**RE: FILE # SE 23-1127
SECOND ORDER OF CONDITIONS FOR BELLA VISTA ISLAND**

On behalf of the Applicant (U.S. Postal Service) and in accordance with the Massachusetts Wetlands Protection Act and the Town of Fairhaven Wetlands Bylaw, Gordon R. Archibald, Inc. (GRA) has submitted a Notice of Intent (NOI) for proposed pavement resurfacing and related exterior improvements at the above-referenced facility. A Public Hearing on this NOI was opened at the Conservation Commission's January 13, 2020 meeting, at which GRA provided an overview of the project, resource areas, and proposed measures to protect resources from impacts, and answered questions posed by the Conservation Agent (Staff Report dated January 8, 2020) and Commission Members. As MassDEP did not issue a file number at the time of this hearing, the NOI could not be put to vote and was continued to the next meeting date (January 27, 2020).

RE: Proposed Auto Dealership, Fairhaven, MA.
Notice of Intent / Site Plan
250 Bridge Street.

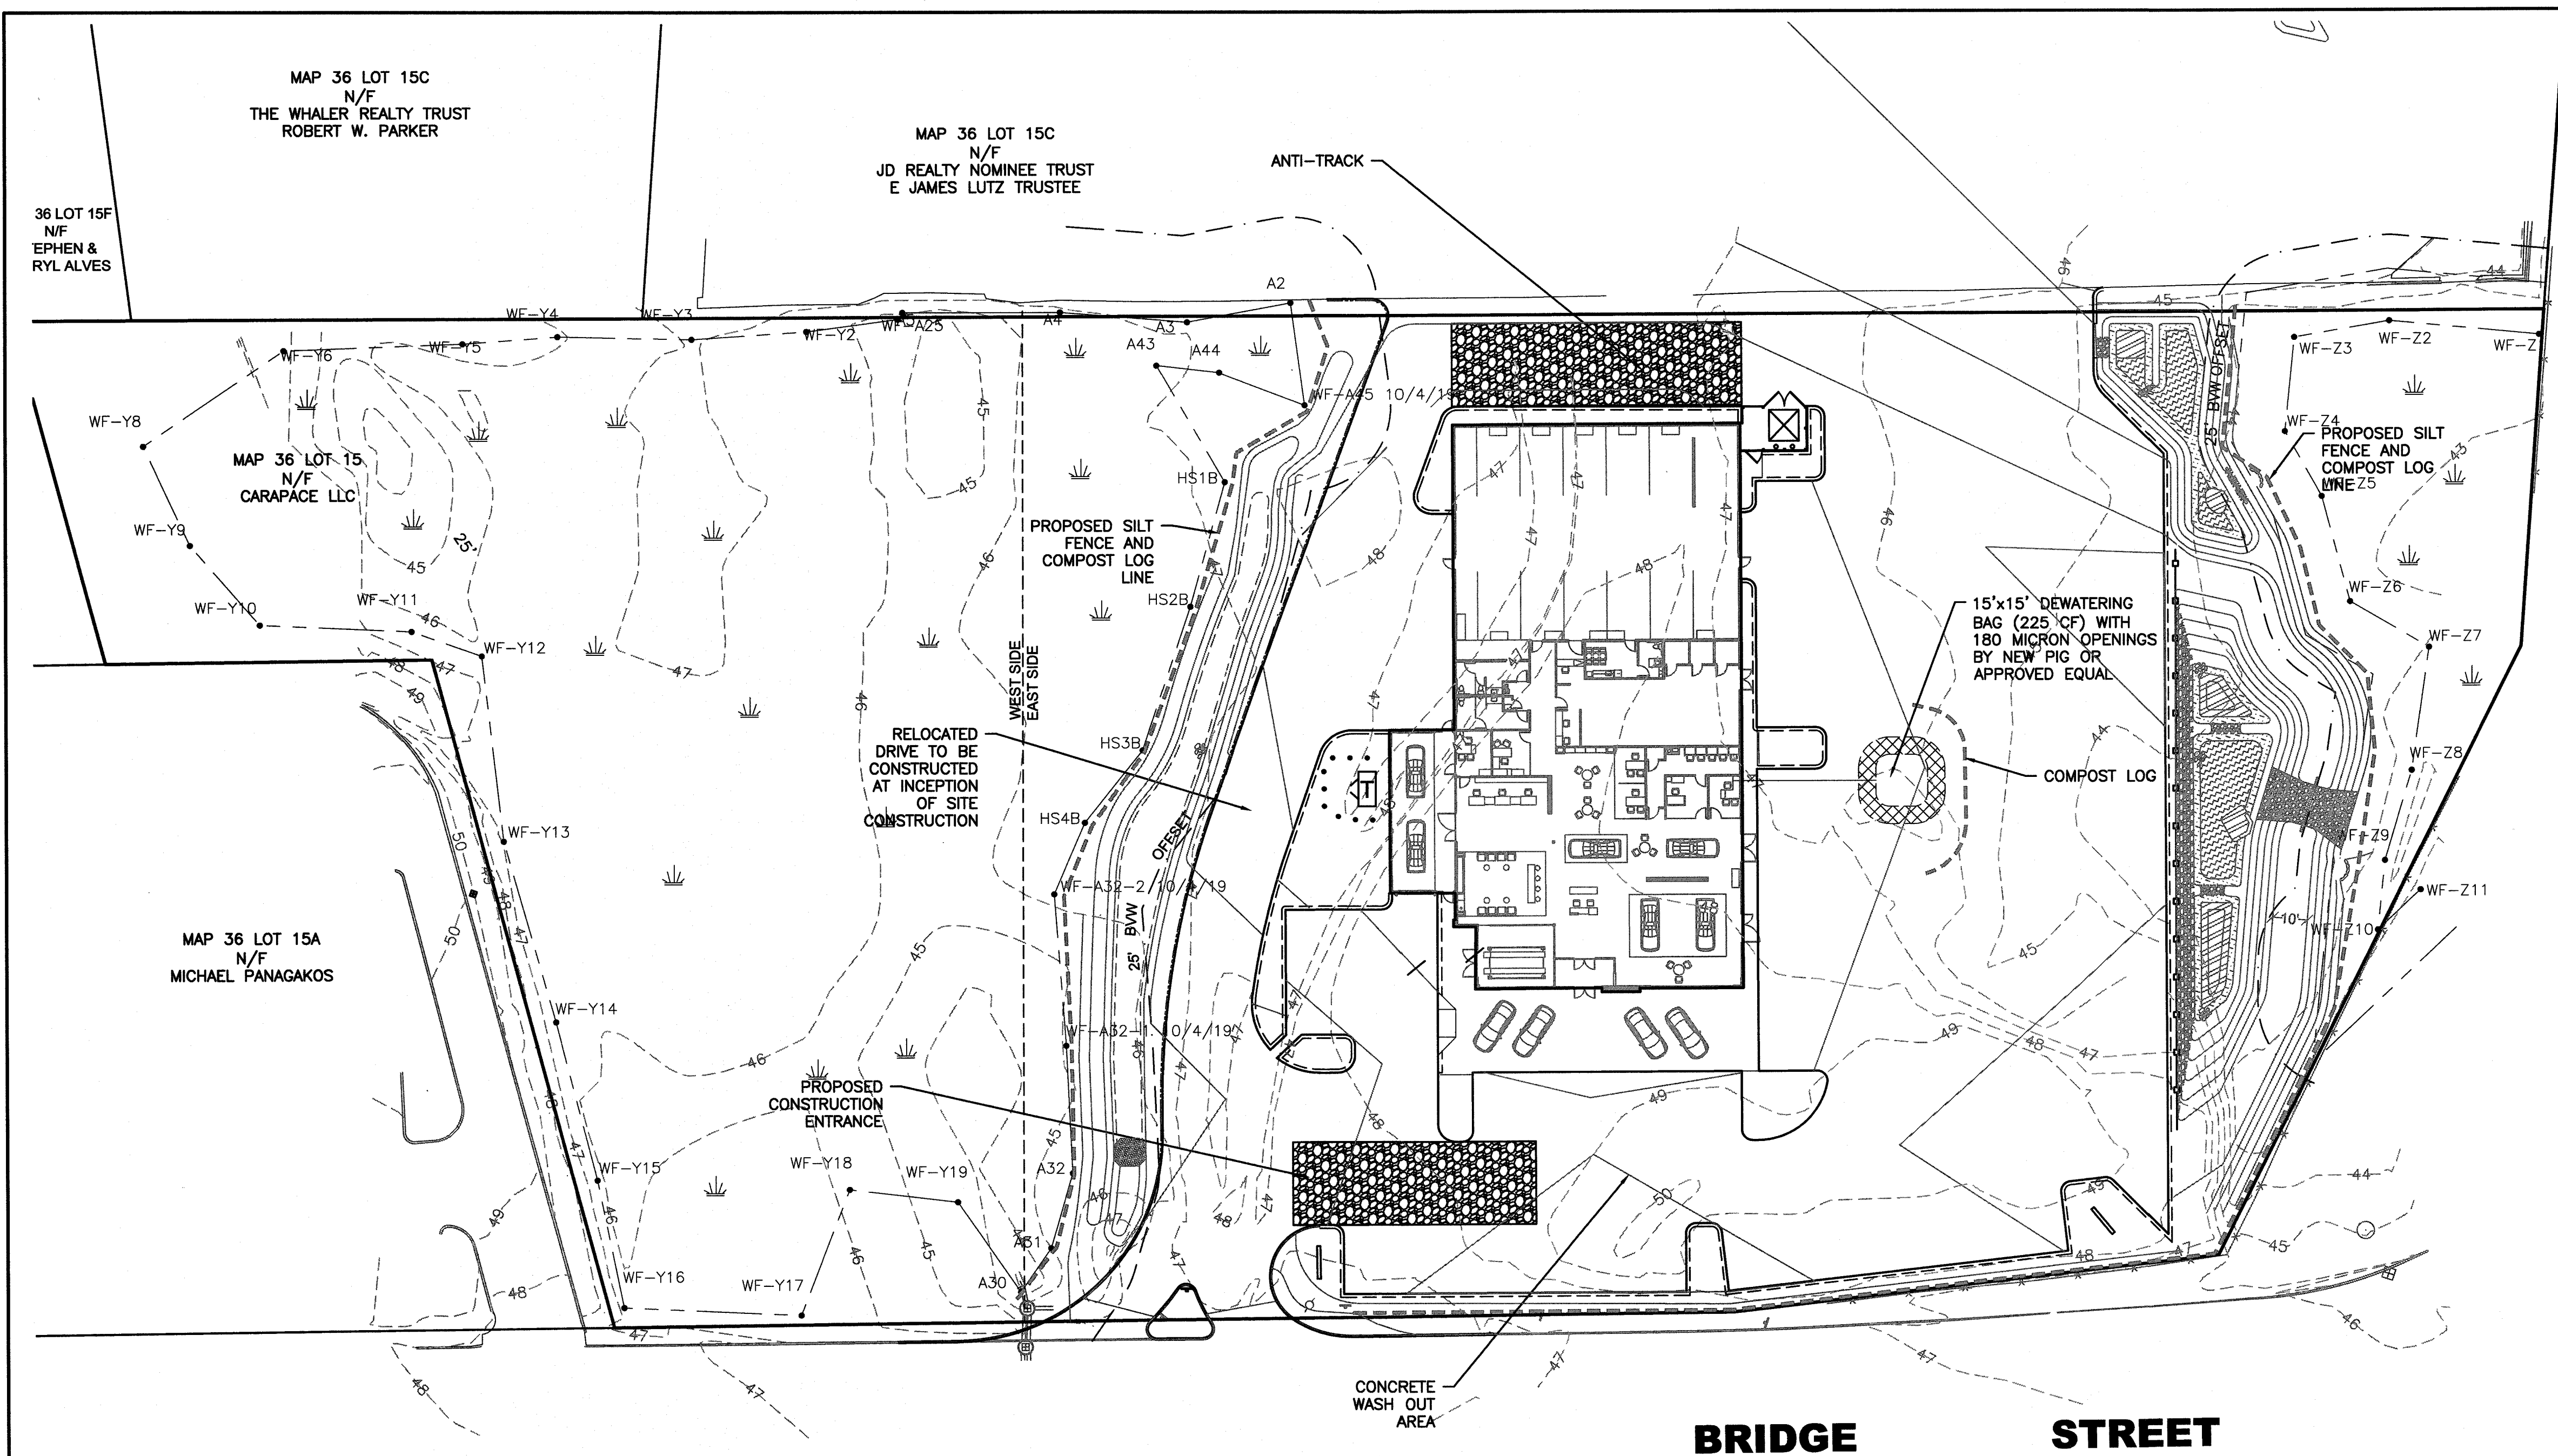
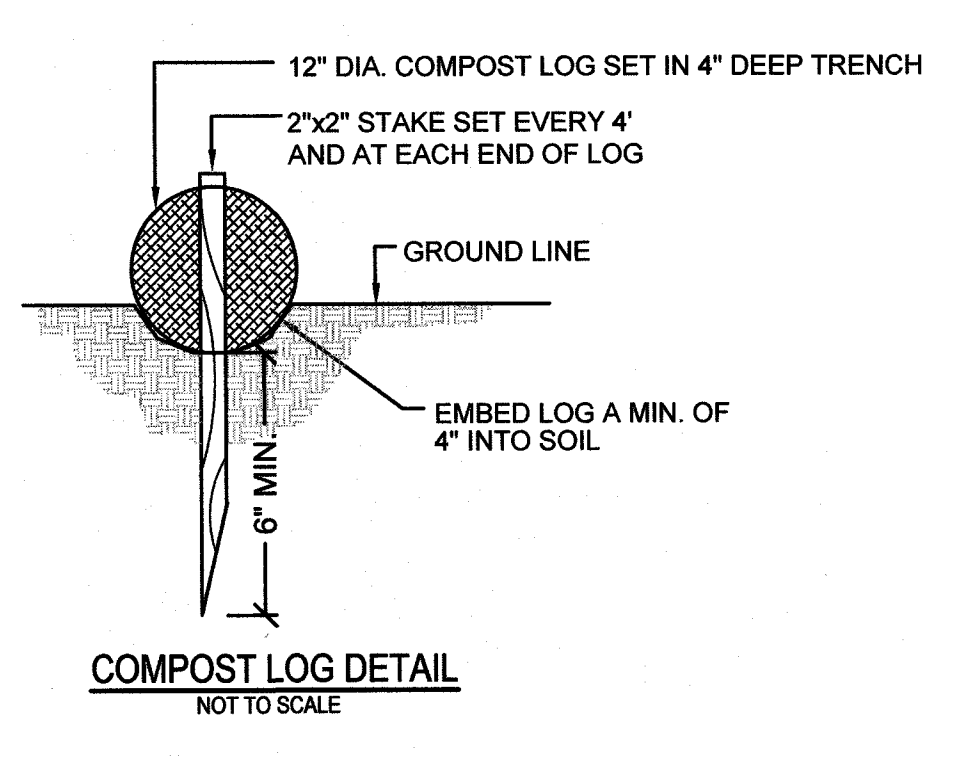
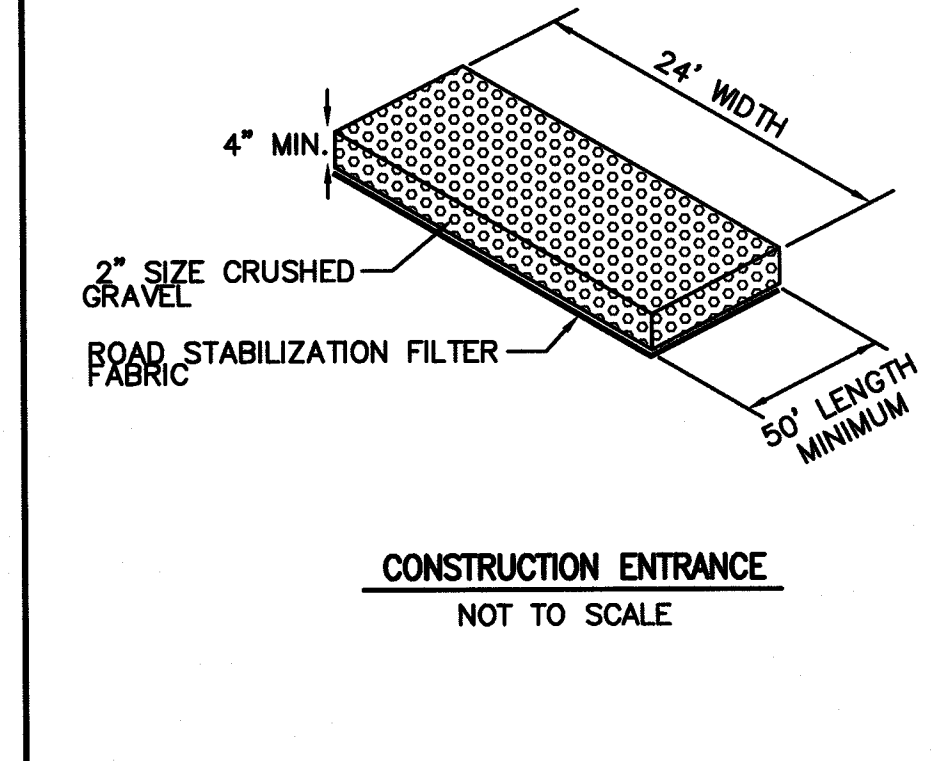
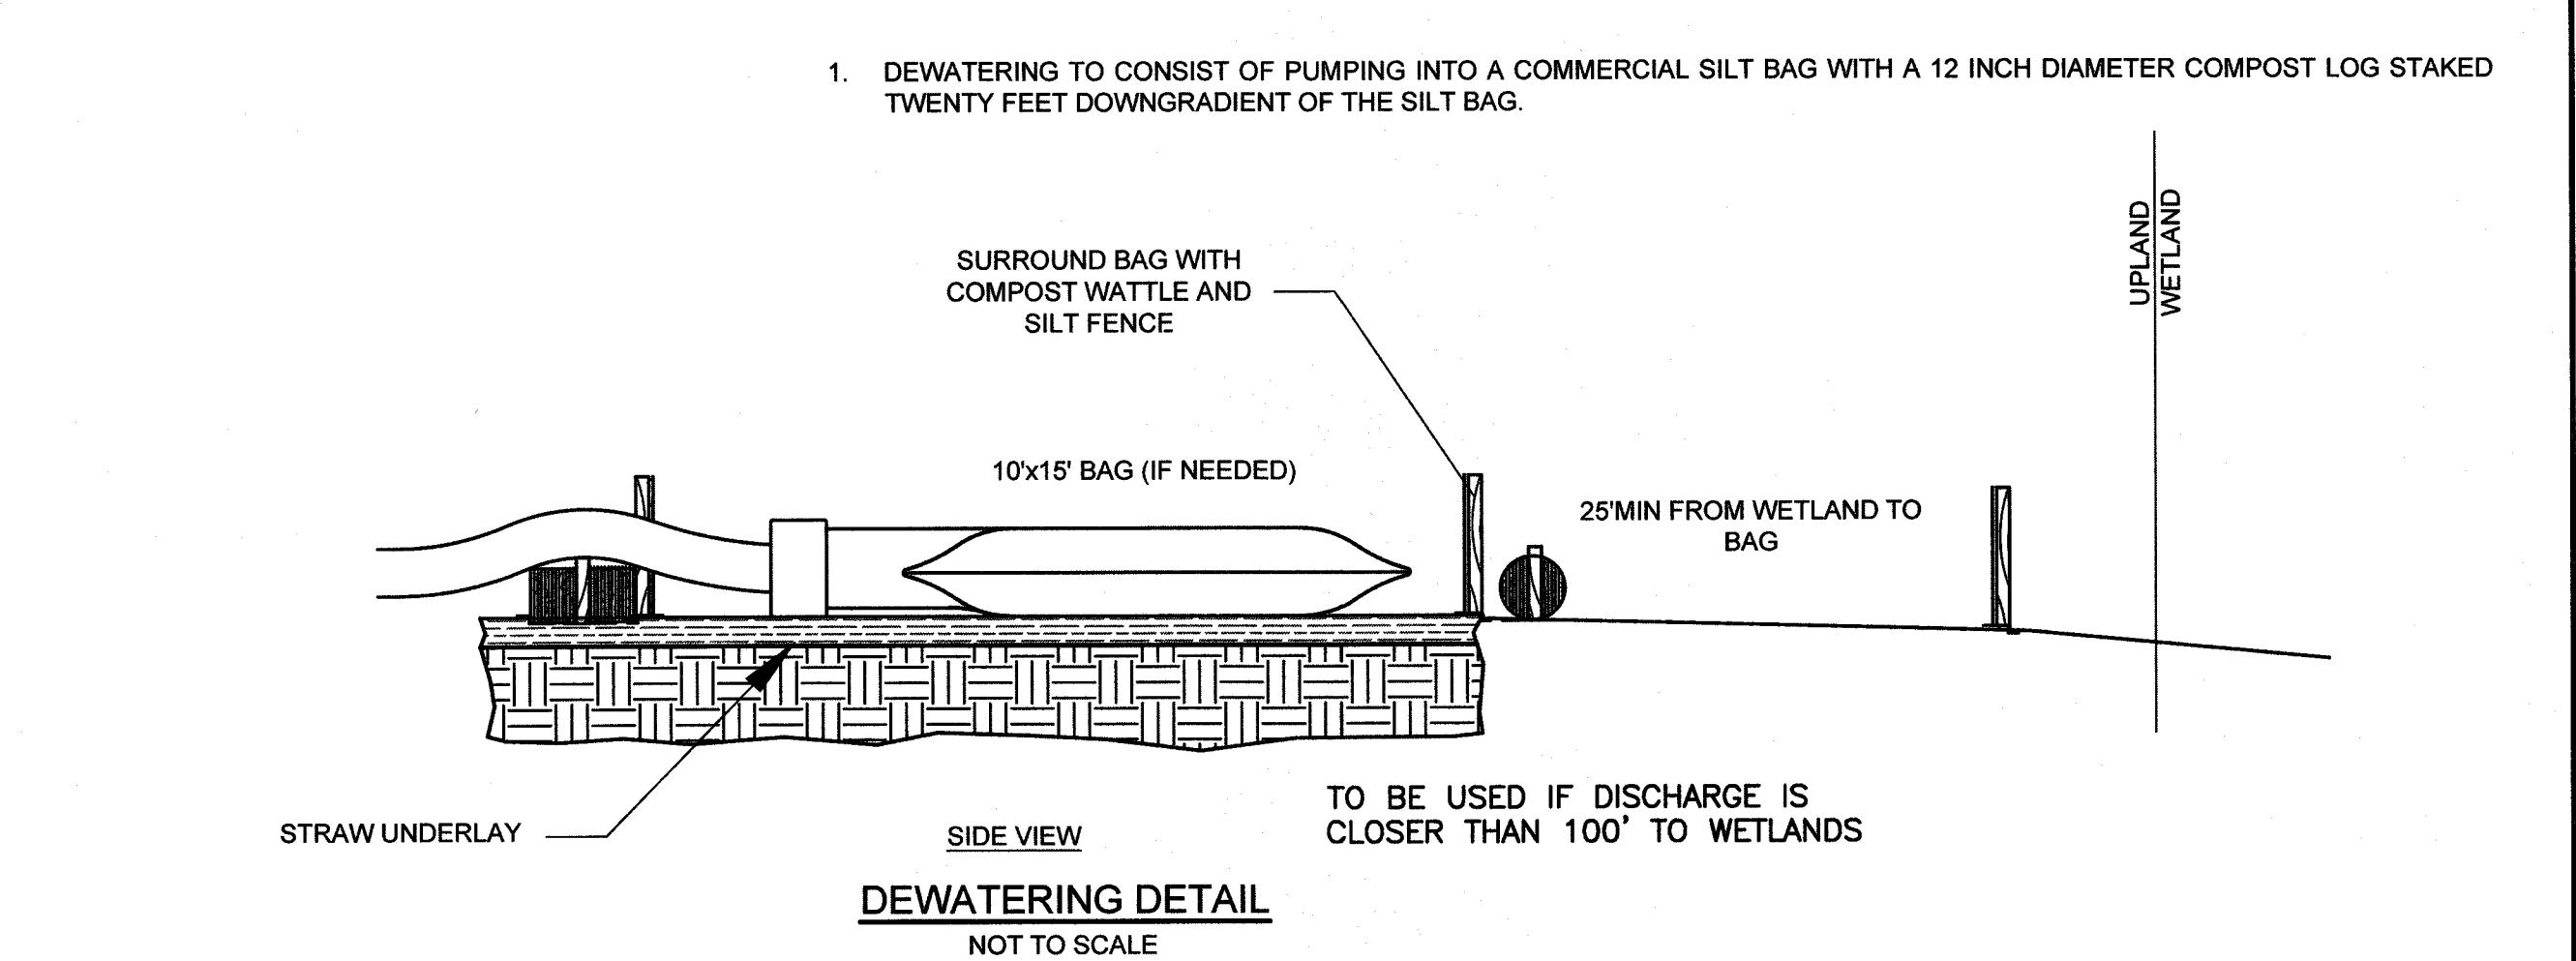
17. Pocket wetland area component (percentage calculations based on MSH Vol. 2., Ch.2, Pg.43) should be provided and shown on the plan. The pocket wetland components have been presented on Sheet 9. See comment Sheet 9 below.
18. Site erosion control plan should be included, at a minimum, silt sack and silt fence/wattle/haybale should be installed during construction, existing pavement could be utilized for construction exit with inspection and sweeping operation. An erosion control plan has been added. Catch basin silt sack should be installed at the two catch basin located west of the site driveway and catch basin at the intersection of Route 240 and Bridge Street.

Silt sacks have been added.
